Dodge Truck Adapter Harness

OLD

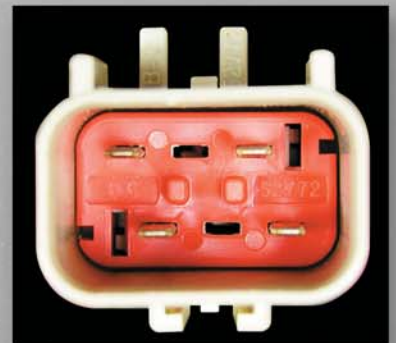
Several fuel pump assembly applications for 1996-1997 Dodge trucks contain an adapter harness to plug into the original vehicle wiring harness.

The adapter harness on the replacement fuel pump assembly has a 4-pin connector, which differs from the 6-pin connector on the original fuel pump assembly.

The original fuel pump assembly unit only uses 4 of the 6 pins in the connector. The vehicle harness, though containing 6 pins, only uses 4.

- The OE vehicle harness mates with the replacement unit adapter plug.
- Though they differ in appearance, the mating connectors are correct and perform to the OE specification.
